IBM System Storage SAN Volume Controller

Service Guide - Errata

Version 4.1.0

August 3, 2006

Figure 20. Ports not used

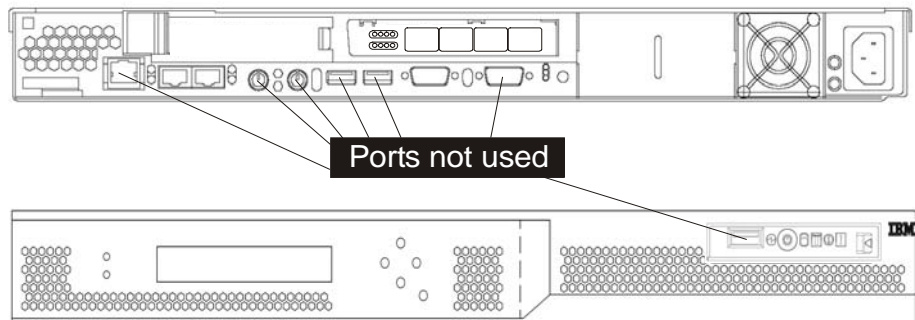
Correction to the list of ports not used.

The SAN Volume Controller 2145-8F4 is equipped with several ports which are not used by the SAN Volume Controller, and have not been tested. Use of these ports, in conjunction with the SAN Volume Controller 2145-8F4 or any other application that might be run on this hardware, is not supported. See Figure 20 for those ports that are not used. In some countries these ports will be covered with self-adhesive non-removable labels.
